Goods and/or Services: Vertical/Architectural Design Build Projects for Marine JFRD Historic Display Building

Recommend approval to amend the award with Auld & White Constructors LLC to implement Amendment #7B to incorporate the attached scope and fee in Exhibit I-1 in the amount of $395,700.00. The new total expenditure not to exceed $1,098,300.00.

CHANGE ORDER NO. 1

Structural Condition Assessment
Jacksonville Fire Museum
Jacksonville, FL

FIRE MUSEUM
REPAIRS
FIRST FLOOR FRAMING PLAN

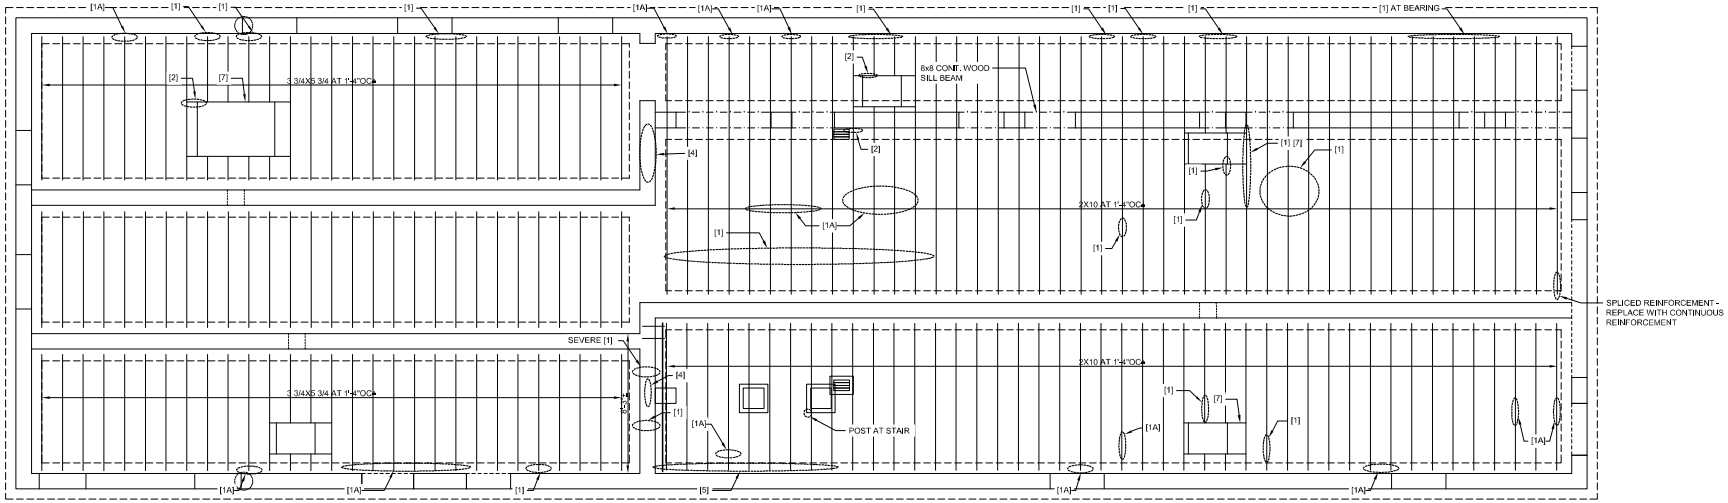
1. TERMITE DAMAGE AT JOISTS
   A. POORLY REINFORCED
2. JOIST UNSUPPORTED
3. CUT JOIST
4. DECKING ROTTED
5. JOISTS POORLY SHIMMED
6. JOIST BRIDGING DAMAGED TYP.
7. HATCH FRAMING NEEDS REINFORCEMENT

1. Based on our analysis, the floor joists require reinforcement in order for the floor framing system to have sufficient capacity to withstand the loads induced by heavy equipment. Any joists that have been improperly reinforced in the past will need to be corrected, and additional reinforcement is likely needed as well at these locations.

5. Typically, the floor framing is not anchored to the foundation system. Anchors must be installed to ensure proper load path and stability.
